DATE: June 3, 2015

SUBJECT: Conditional Use and Site Plan Review for 5133 Darrow Road  
LifeCenter Plus – Proposed outdoor volleyball courts

PC Case No: 2015-15

RE: PC 2015-15- Site Plan review for LifeCenter Plus

C-2

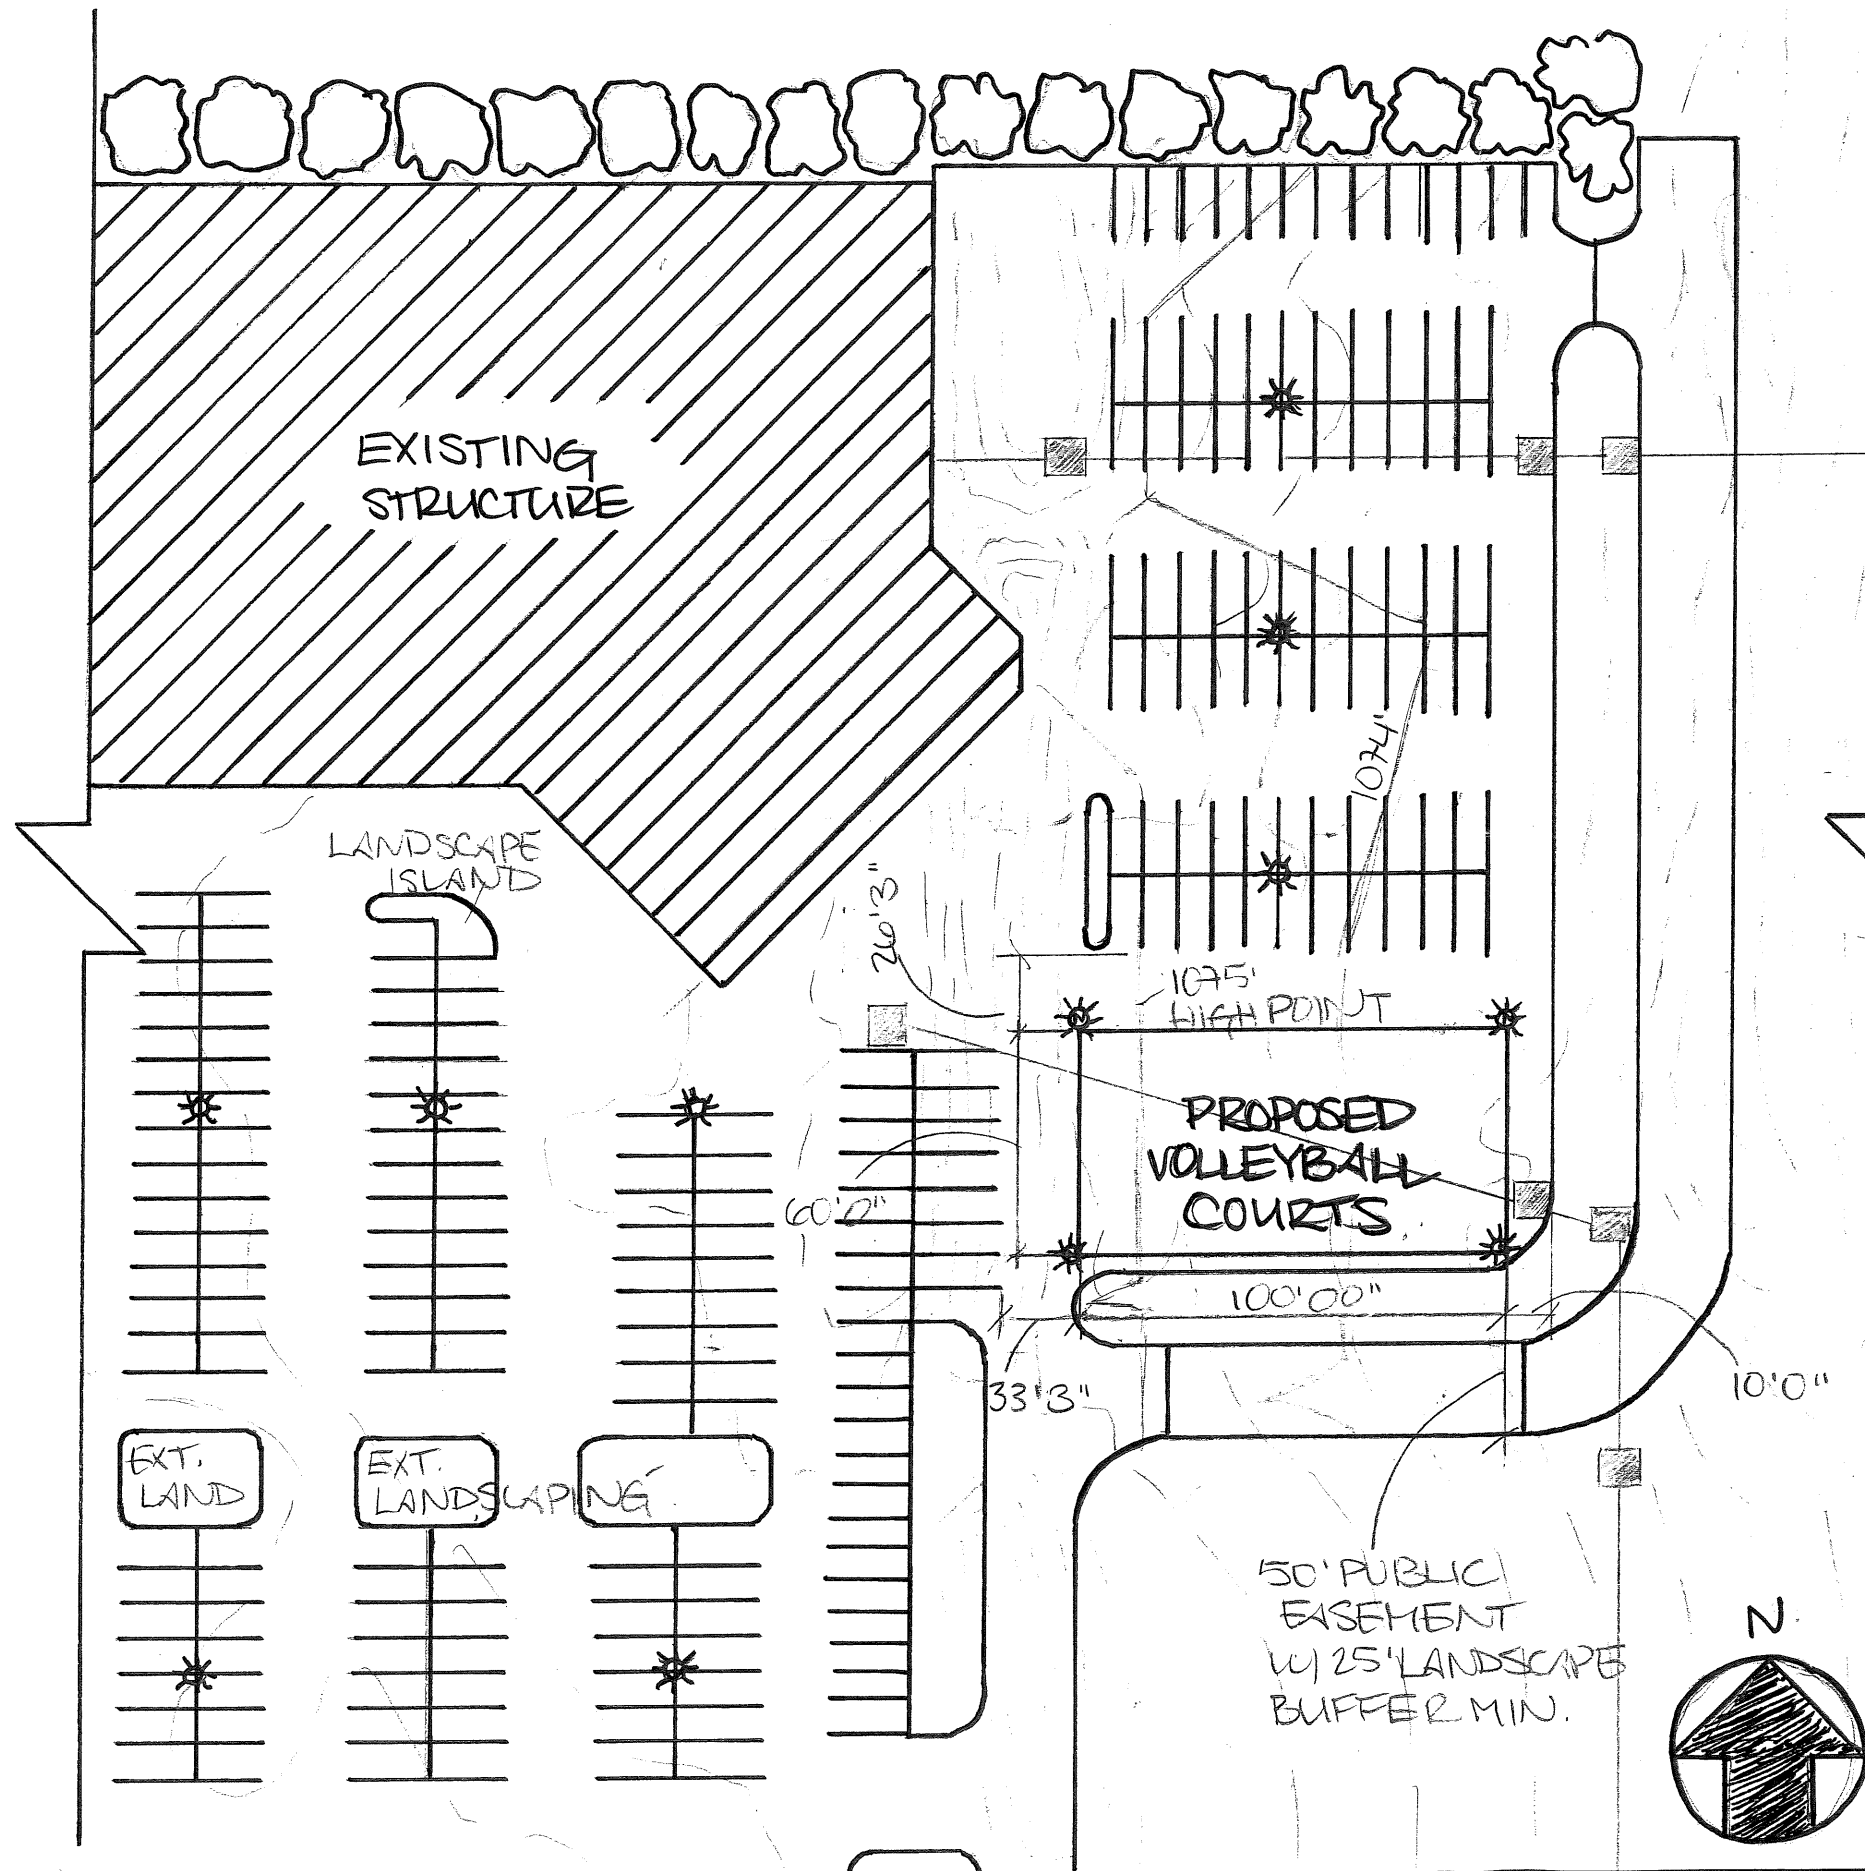
The proposed project involves the removal of 20 parking spaces from the facility. Section 1207.12 requires recreational facilities to provide one parking space per three persons at capacity. Additional information is needed regarding the capacity of the current facility to determine if adequate parking is accommodated.

The proposed project involves the removal of 20 parking spaces from the facility. Section 1207.12 requires recreational facilities to provide one parking space per three persons at capacity. City records and information through the Hudson Fire Department shows that our Outside Pool Facility Total Capacity is 769. The ½ Mezzanine is 150 persons; the Conference/Business Area is 135 persons; the Pool area is 122 persons; and the deck area is 362 persons. 322 parking spaces is the current lot number – with the removal of 20 spaces, we are left with 302 spaces; and fulfil the section requirements.

E-1

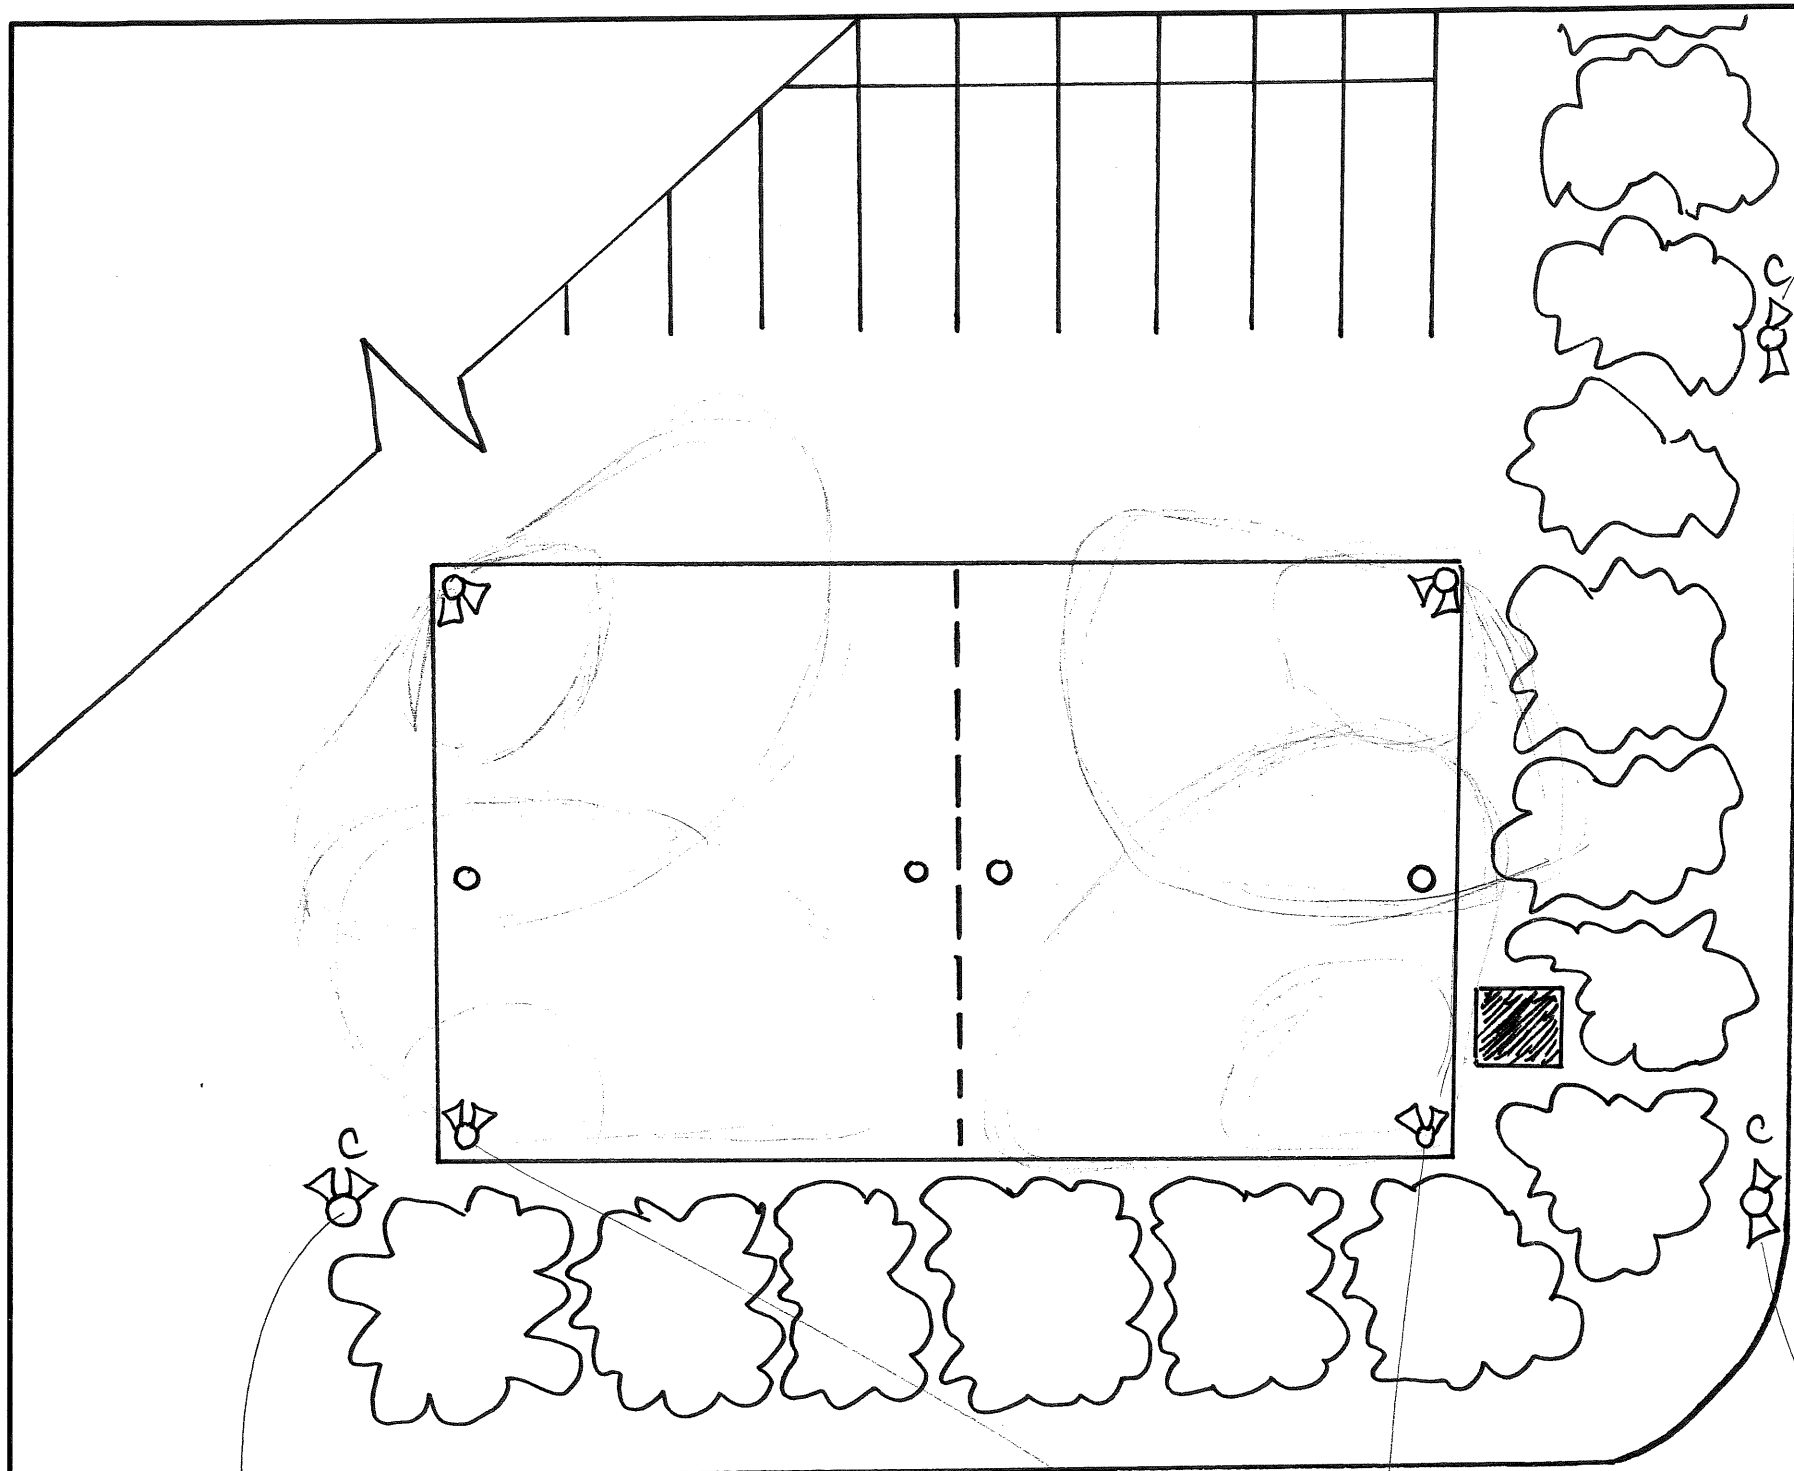
**Exterior Lighting:** Preliminary lighting information has been submitted; however, a photometric layout must be submitted to confirm that lighting level at the property line does not exceed 0.1 footcandles.

Comment: Clarify the proposed pole height as the plan submittal notes 20-25 feet. A photometric layout must be submitted to confirm the lighting level at the property line.

- i. All fixtures are of a full cut off design
- ii. Lighting levels at the property line cannot exceed 0.1 vertical foot candles. Addendum to this letter is documentation confirming the photometric light spread a light fixture for the proposed area. Per your email, you mentioned that typically these layouts are site specific designs; however, a generic light spread would be suitable as well.
- iii. Maximum lighting fixture mounting at 25 feet, the same height as current parking lot fixtures. Permitted within District 9, suggestions are at or below current parking lot fixture heights.
